# Access Compliance Report

## Public Rights-of-Way

Intersection ID: 13156	Main Street: S_TRYON_ST	Cross Street: W_CARSON_BV	Location: SW
ADA ID: 4183D6D7D505	Ramp Type: PerpDiag	Initial Pass/Fail: Fail	Overall Compliance: No
		Severity Score: 22.5

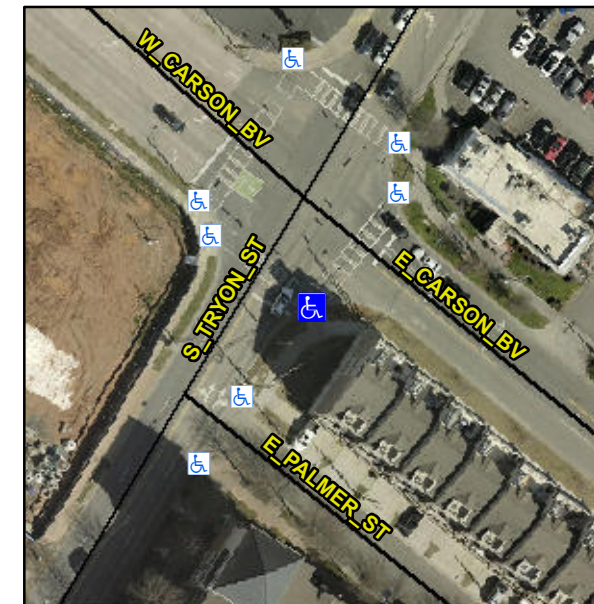
**Not Found, R304.5.1, R304.2.2, R304.5.3**

Compliance	Description	Data	Compliance	Description	Data
N/A	Ramp Length (in)	94.0	No	Ramp Slope (%)	8.6
No	Ramp Width (in)	45.0	No	Ramp XSlope (%)	2.2
N/A	Flare Type LT	N/A	N/A	Flare Type RT	N/A
N/A	Flare Slope LT (%)	N/A	N/A	Flare Slope RT (%)	N/A
N/A	Flare Traversable LT?	N/A	N/A	Flare Traversable RT?	N/A
N/A	Landing Length (in)	N/A	N/A	DWS Provided?	N/A
N/A	Landing Width (in)	N/A	N/A	DWS Contrast?	N/A
N/A	Landing Slope (%)	N/A	N/A	DWS Length (in)	N/A
N/A	Landing X Slope (%)	N/A	N/A	DWS Full Width?	N/A
N/A	Landing Curb? (Y/N)	N/A	N/A	DWS Offset (in)	N/A
N/A	Shared Landing?	N/A			
N/A	Gutter Ponding?	N/A	N/A	Gutter Slope (%)	N/A
N/A	Gutter Lip Ht (in)	N/A	N/A	Gutter X Slope (%)	N/A
N/A	Painted X Walk1?	Yes	N/A	Painted X Walk2?	Yes
	X Walk 1 Direction	To NE		X Walk 2 Direction	To NW
N/A	X Walk 1 Width (in)	112.0	N/A	X Walk 2 Width (in)	112.0
	X Walk 1 Slope (%)	3.6		X Walk 2 Slope (%)	2.4
	X Walk 1 X Slope (%)	5.2		X Walk 2 X Slope (%)	1.9

**Remove & Replace Curb Ramp With Two New Directional Ramps or Equivalent.**
